CITY OF
Ames™

**Supplemental Specifications
To the Iowa
Statewide Urban Design and
Specifications**

City of Ames Supplemental Specifications to SUDAS (2017 Edition)

Date of Last Revision: 02/10/2017

City of Ames Curb Detail

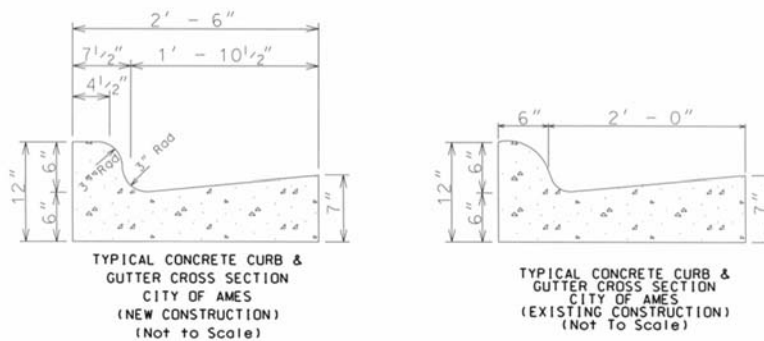
Figure PV-102

Delete Entire Sheet. See City of Ames curb detail below.

A. Add: Construct curb and gutter as per City of Ames curb standard with 30" width and heights of 7" at face and 12" at back with 1" tilt onto curb. An 'ED' Joint is required at each end of a radius.

COA Figure 8010.19

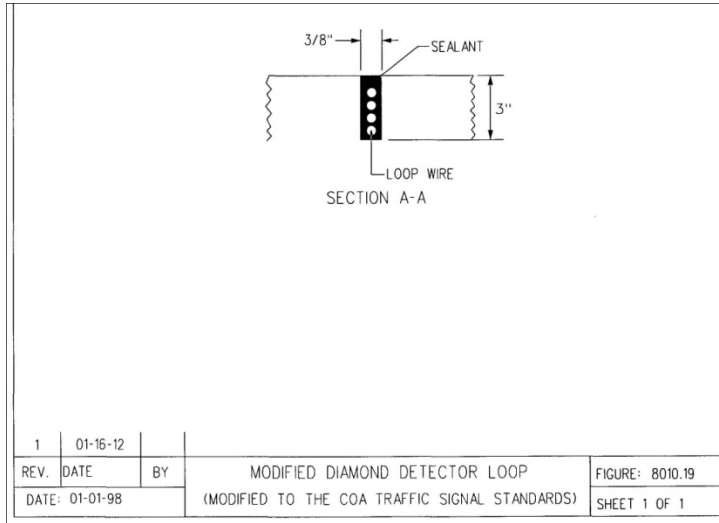
Figure 8010.104

Delete: Rectangular Detector Loop. This style of inductive loop vehicle detectors shall not be used in the City of Ames.

Delete: Section A-A **Add:** Section A-A from Modified Diamond Detector Loop (COA Figure 8010.19)
